Meeting: Special Plan Commission
Place: 1293 Washington Ave, Cedarburg
Date/Time: August 27, 2025 / 7:00PM*
Web Page: www.townofcedarburgwi.gov
Posted: August 22, 2025
***This meeting is also available remotely online. For remote access, email sjacoby@townofcedarburgwi.gov for information.**

PLAN COMMISSION MEETING MEMORANDUM

GAUTHIER POND PLAN

MEMORANDUM

POND PLAN & PROFILES

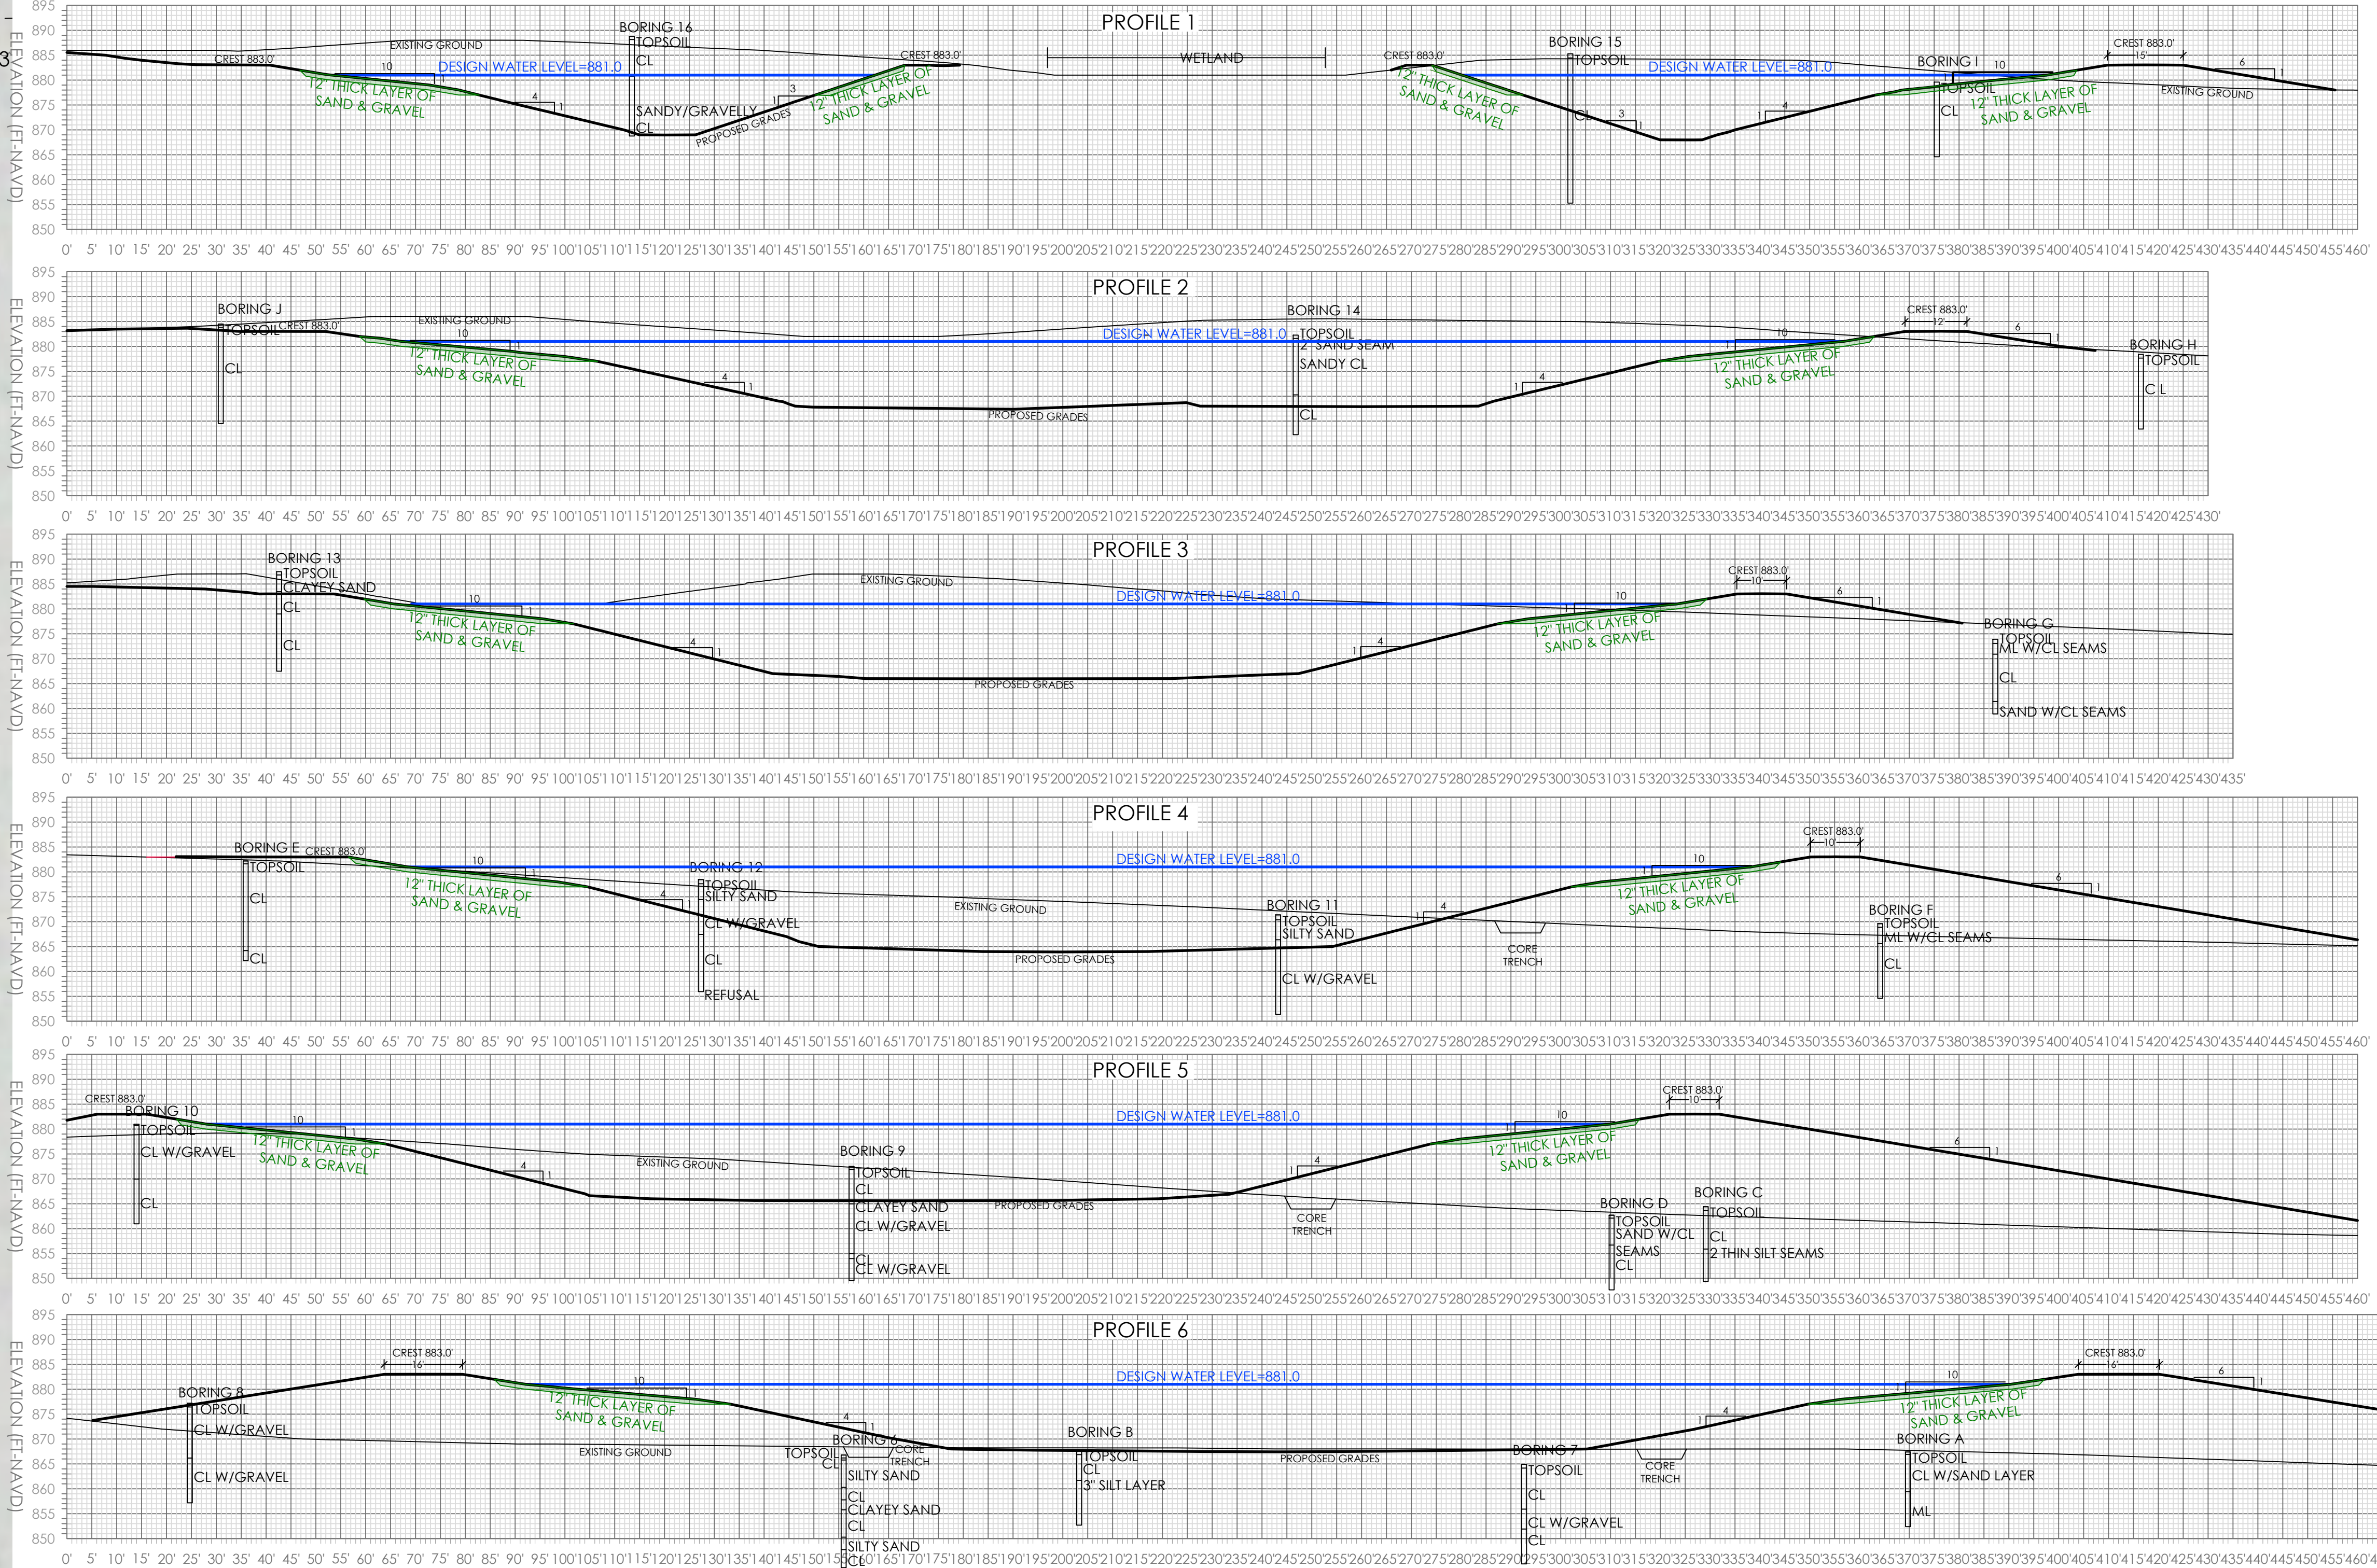
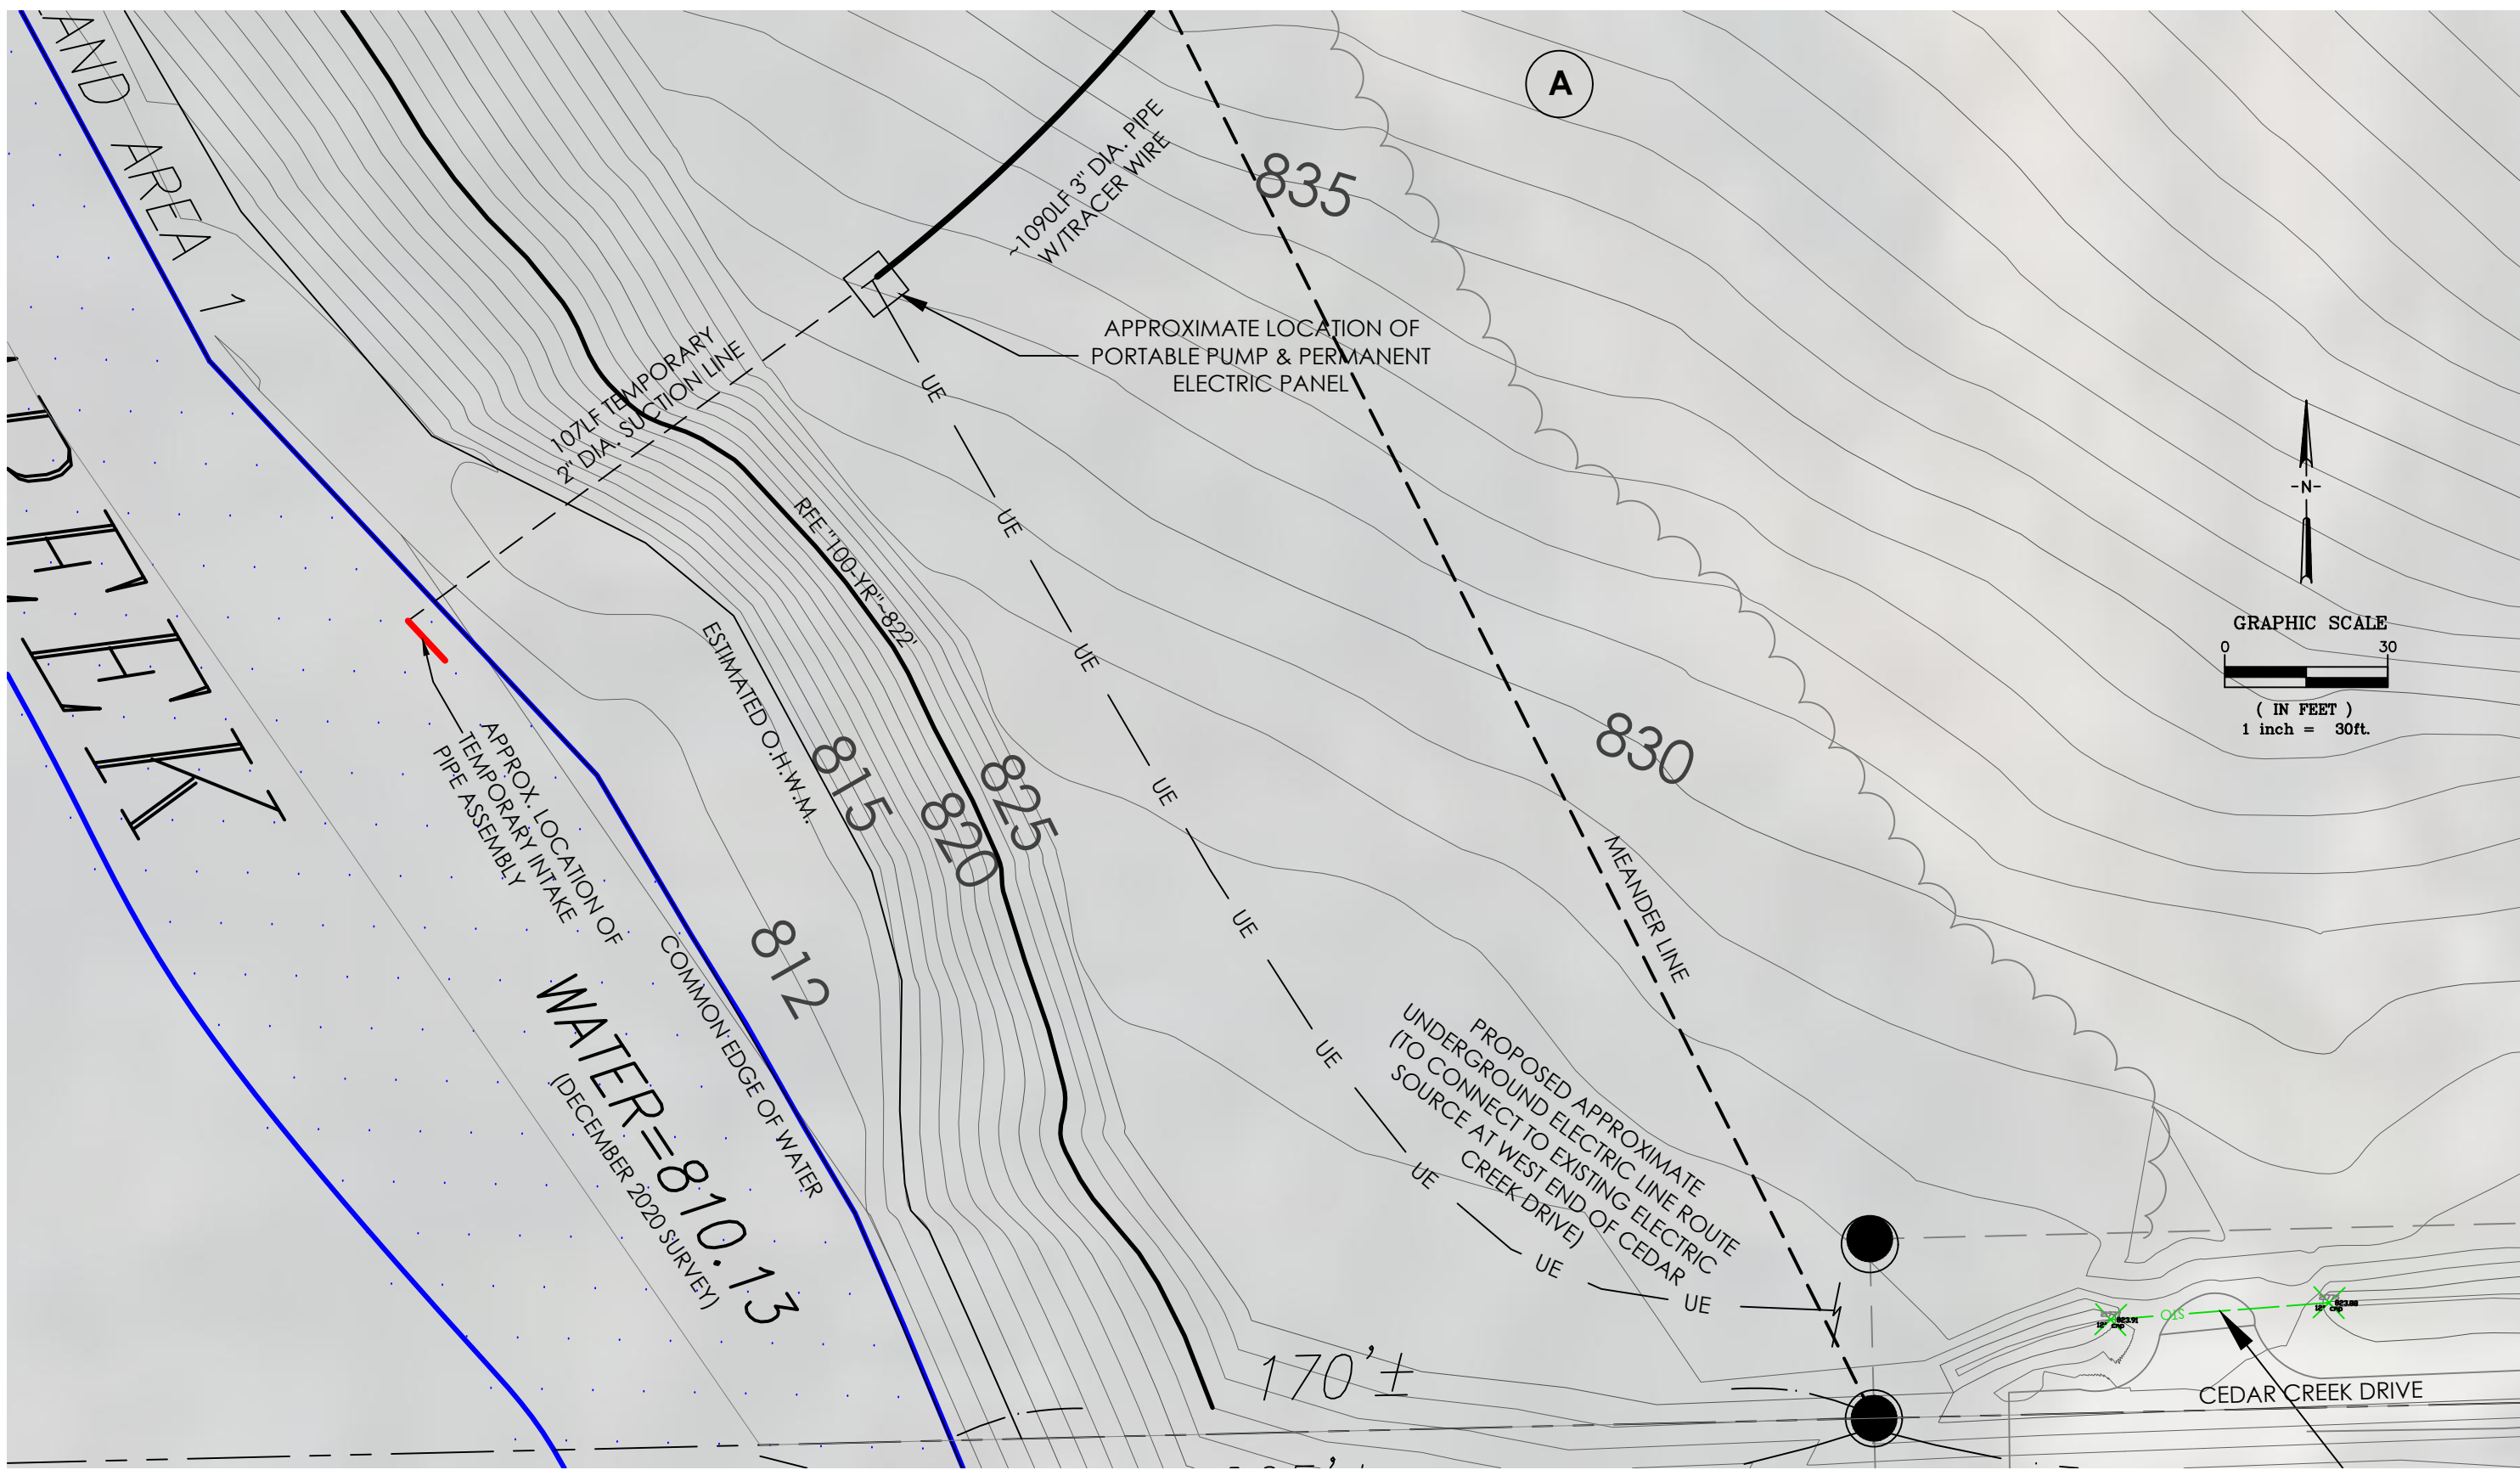
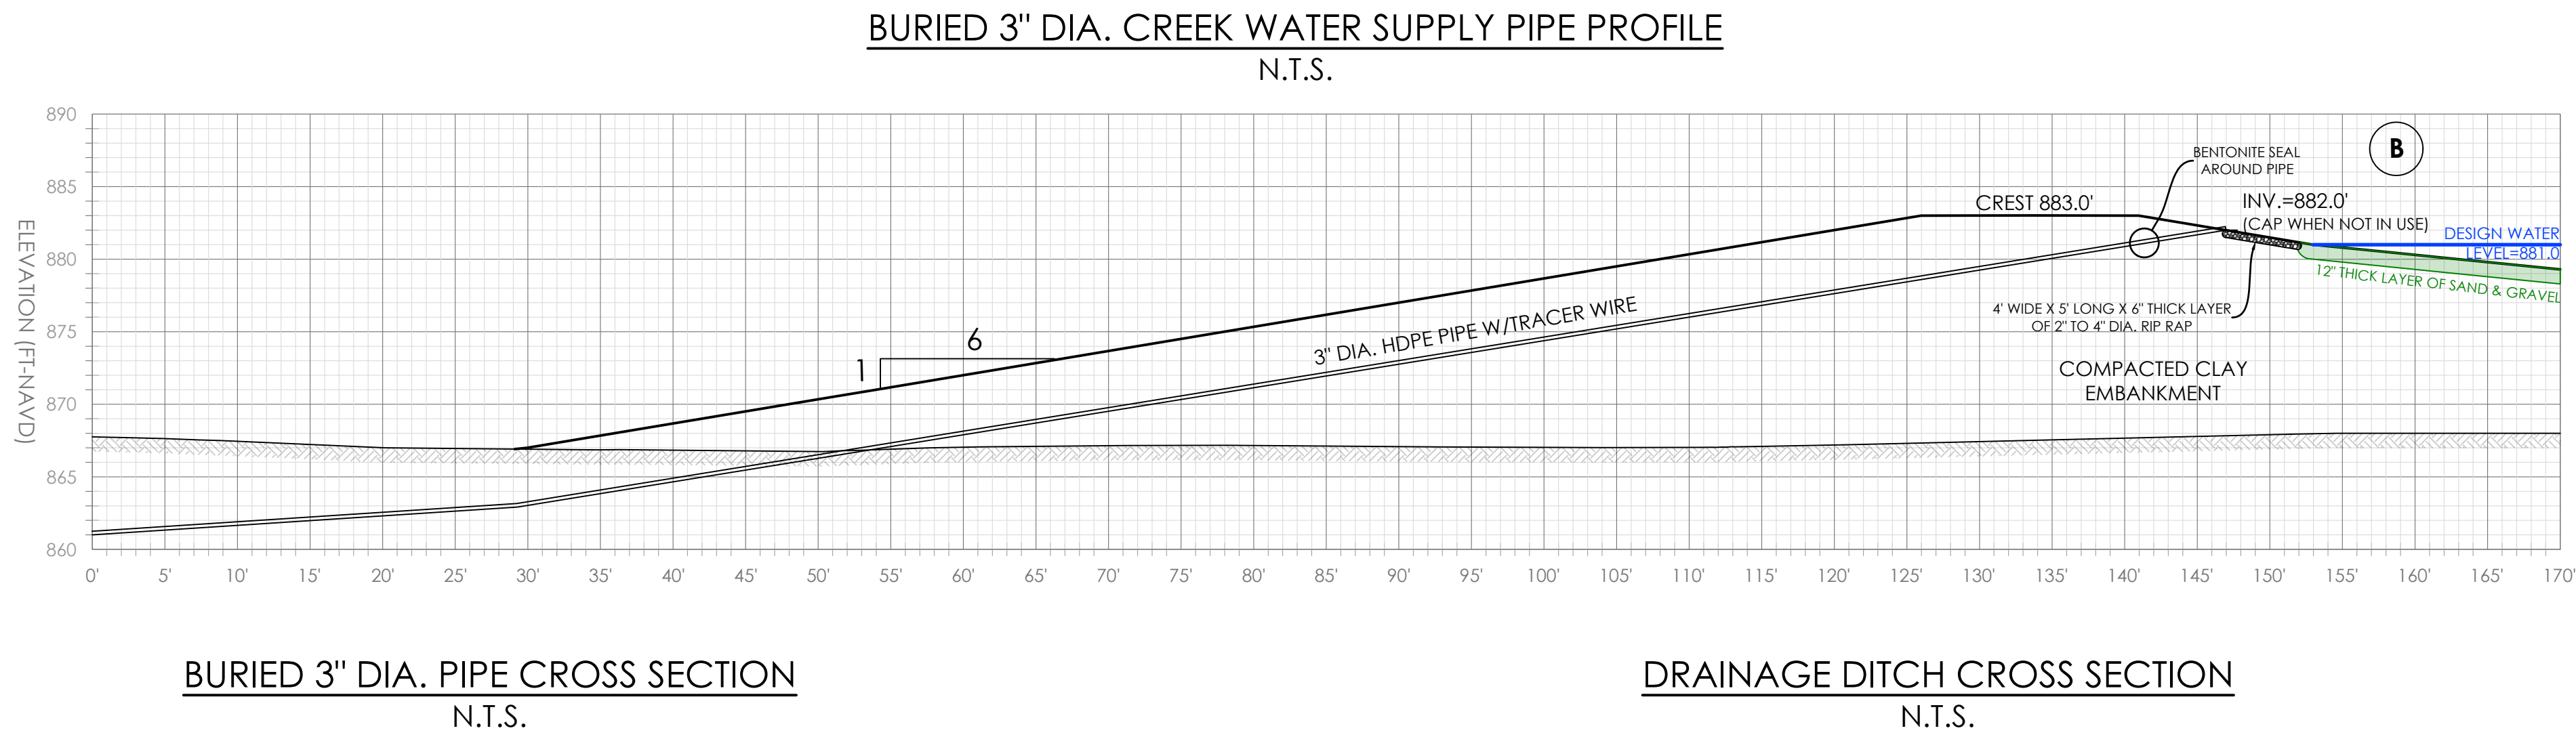
12. On sheet 3 of 3 label slopes of the berm and other lengths and grades. The scale and bar that is on the plan sheets are lacking or very hard to follow with such a small scale.
Applicant Response: Label slopes – Comment addressed – shown on pond plan page 3
raSmith Response: Comment partially addressed. Please show elevations at grade breaks within the cross-sections within the pond that can be verified when completing the as-built survey.

15. Compaction shall be completed in maximum 8-inch lifts.
a. Note 6 on sheet 3 of 3 mentioned the engineer being contacted if there are concerns with compaction or soils. Who is responsible for contacting the engineer? The engineer should be doing daily testing of the compaction of this embankment.

a. What is the reason for the sand and gravel layer?
b. Note 1 and 3 on sheet 3 of 3 reference the sand and gravel to be extended either 3' or several feet. If allowed, the note should be consistent with one dimension.

b. The Town will then review the test results as part of the as-built.
Applicant Response: Compaction – Comment addressed, now 8" lifts, testing by engineer
raSmith Response: Comment addressed; the plan now states the appropriate lifts and this can be confirmed during construction.
